Re: SR1 Risk Comments

Our comments address CEAA's draft conditions of January 4, 2021 along with Package 4-Technical Review Round 2, March 23, 2020 and July 2020, and the Proponent's land-use plan from October 2020 (Question 4-05) among other items from the Proponent's prior submissions. We have not had the opportunity to adequately review the most recent December 18, 2020 Project Design given the holidays and requirement to comment on CEAA draft conditions by February 3, 2021. We remind regulators that we are community volunteers who spend inordinate amounts of time keeping up to date with submissions. We also express dismay that the NRCB Pre-hearing took place before the latest design was released. We did not have any indication that this updated design was imminent and it has created additional work for our volunteers. Additionally, the February 3, 2021 deadline for CEAA comments on conditions proposed on January 4, 2021 does not allow adequate time for robust review and comment. The CEAA deadline should at least include the expert evidence that arises at the NRCB hearing. To omit this evidence may result in missed-opportunities to improve Project outcomes.

Hydrometric Stations:

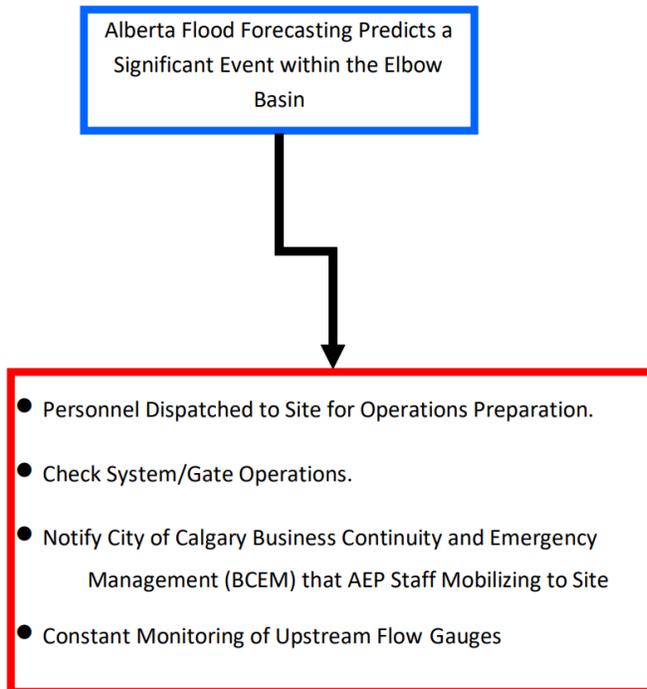
Is the assumption that hydrometric stations in operation DURING a flood event will be operational? The Proponent's statement uses the words "in operation prior to a flood season". What happens if the monitoring stations malfunction or do not properly read flood volumes as in 2013? What is the approach to diverting water? Visual cues? Based on what? This is a really big assumption and it would have been WRONG in 2013.

Decision to Divert:

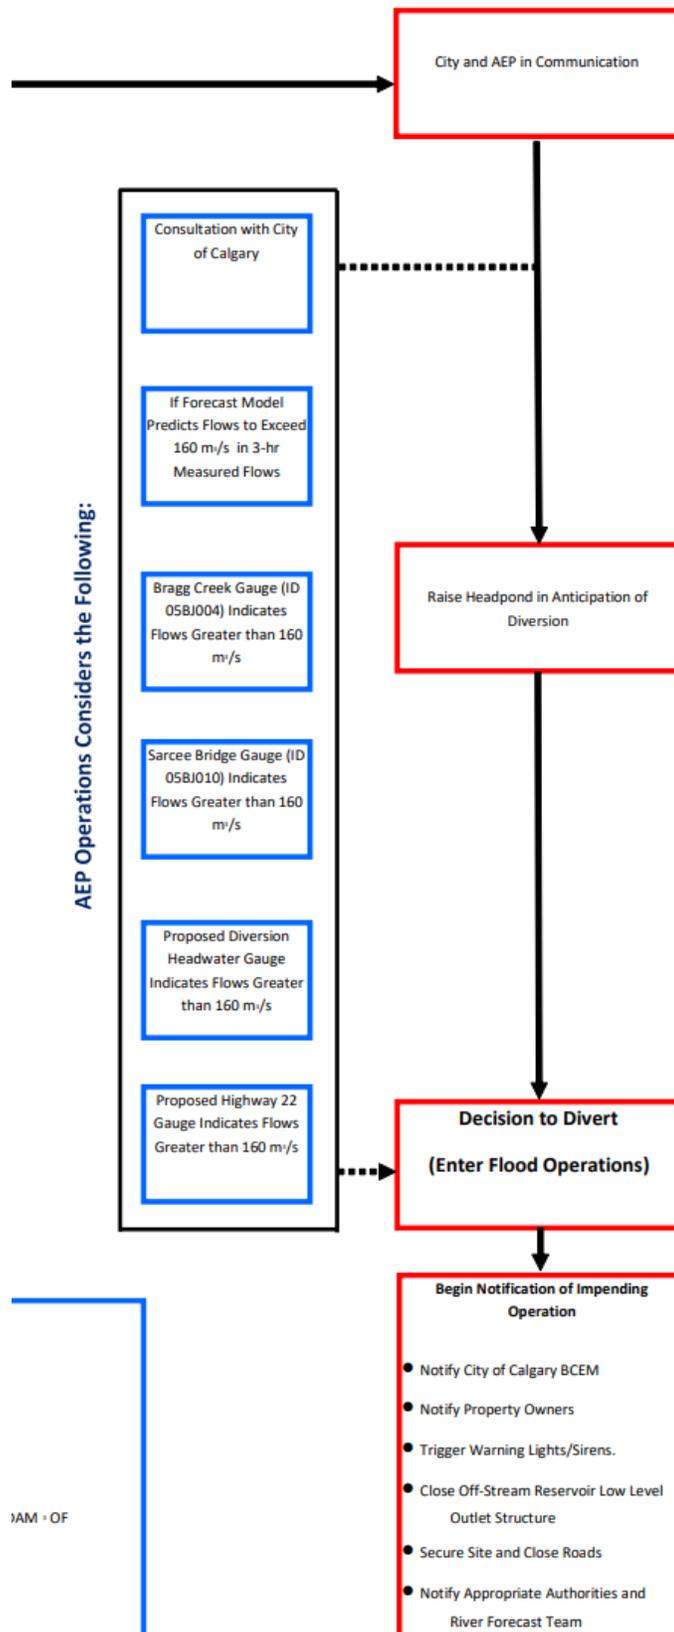
Comments:

- This is late for notification of residents in the area
- Also, closing roads will take time which is not considered

Questions:

- Do all stations need to read >160cms?
- What if one station is not reading? Does it matter which station?
- What if more than one station is not reading? Does it matter which stations?

- What if the station readings are contradictory? I.e. some are <160cms and some are greater?
- Is it possible that the Diversion gauge may not be accurate due to backwater behaviour or impacts of debris?

- Which gauge is the leading indicator of flood? Bragg Creek? Are there no stations upstream of Bragg Creek?
- In a river that is increasing in velocity, what is the variance that can exist between Sarcee Bridge and Bragg Creek? How is this accounted for and incorporated into the decision? For instance, is there a scenario where Sarcee is <160cms but Bragg Creek is more? How will this be reconciled and used in operations?

- Will the diversion be stopped if data readings are contradictory or suspected to be impaired?

Flood Operations

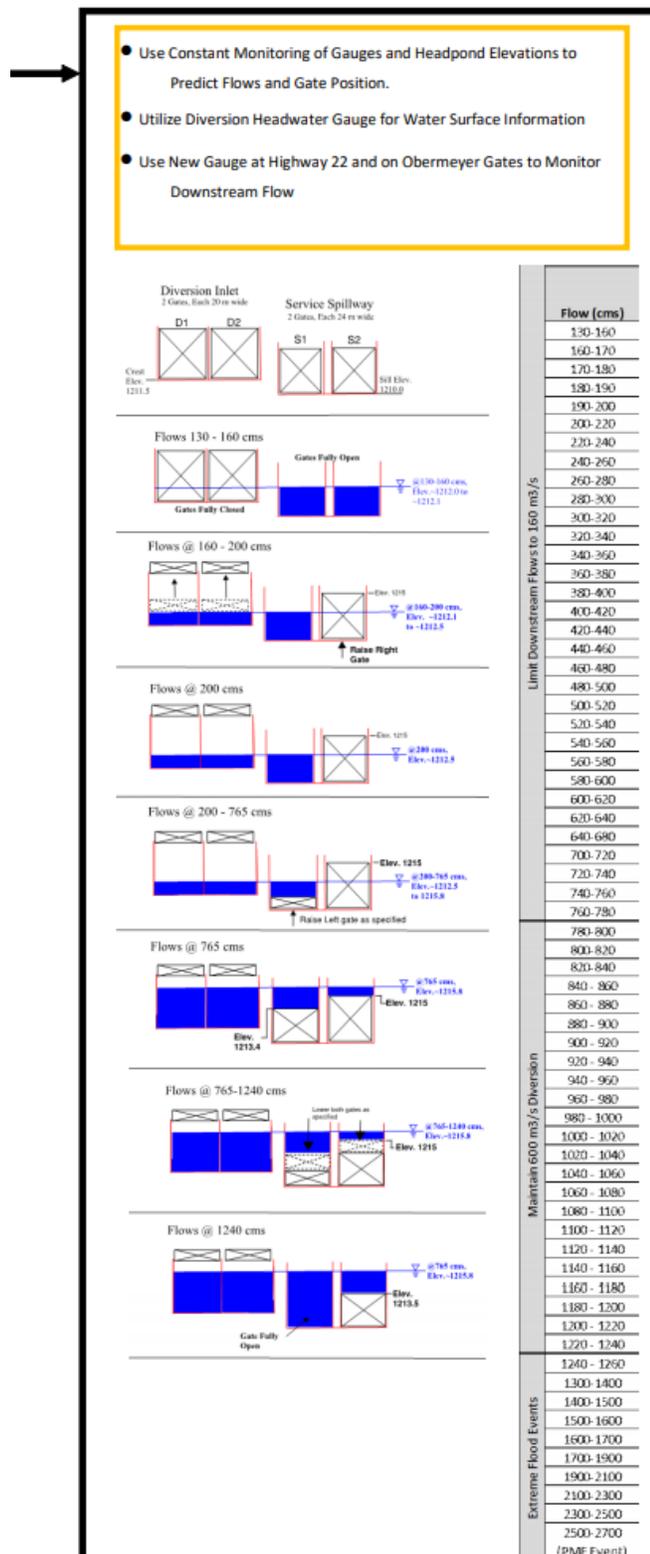
- Operations over 1240cms are not identified.
- There is no reference to measuring the reservoir elevation here at all in order to assess if SR1 is approaching its full capacity. How will this elevation be measured and what level of confidence exists around this measurement?

Stop Diversion:

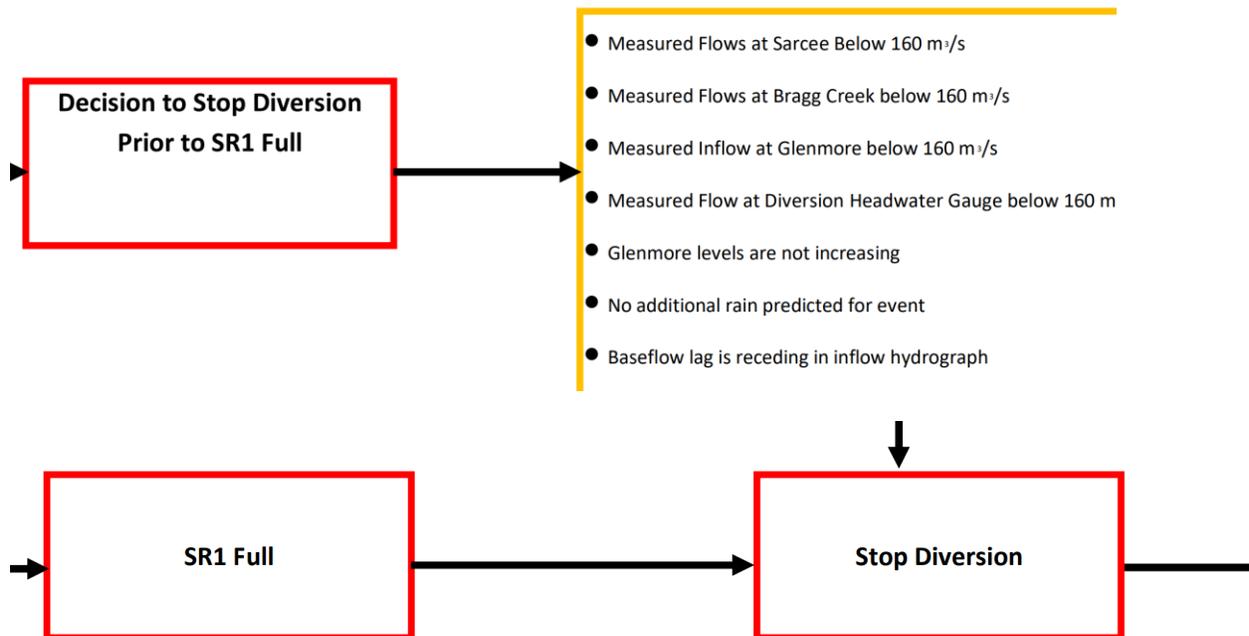
- The SR1 “Full” box is glaringly empty.
- How is SR1 determined to be full and how is water in the diversion channel accounted for?
- Is someone monitoring the emergency spillway to see if it is activated as an indicator of full pool?
- There should be some warning or indicators for “SR1 Full” assessment, should there not? Will the water levels in SR1 be difficult to read if there is wind or unexpected behavior of the water in the reservoir (waves)?
- What is the impact of sediment deposition in the reservoir and its impact on elevations / volumes?

Alternate Operations Schemes

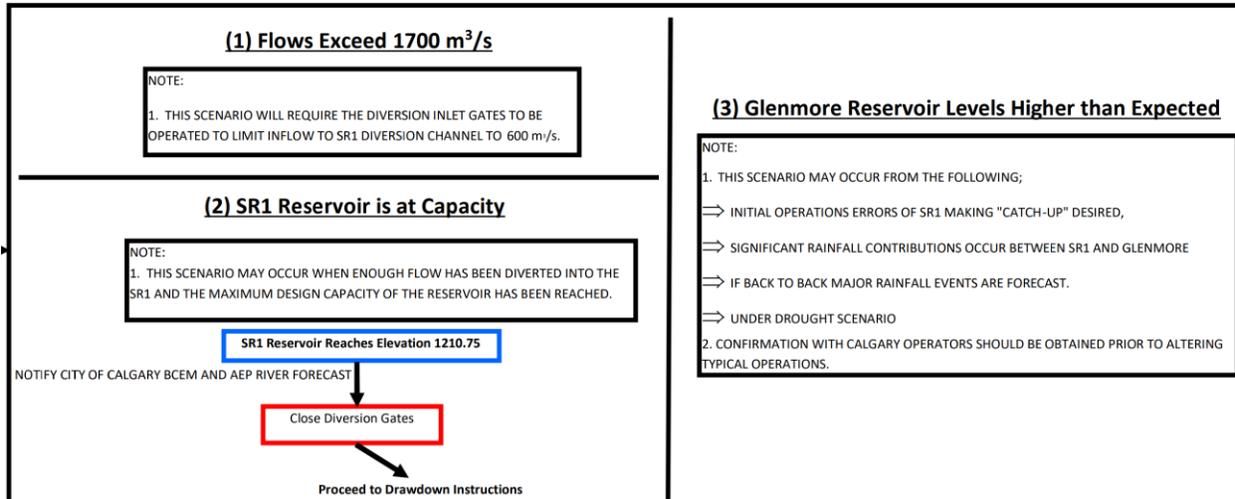
- It is clear that the focus is protecting Glenmore “Confirmations with Calgary operators should be obtained prior to altering typical operations”. Is this the right protocol? Again, the main priority of SR1 operations should be to SAFELY operate SR1. That may sometimes contradict the best interests of Glenmore Reservoir operators and result in competing outcomes.
- We are concerned that the first fill(s) of SR1 will be full of uncertainty and operating risk. How will this elevation be established during a frantic diversion during a severe weather event? What is the margin of error here?
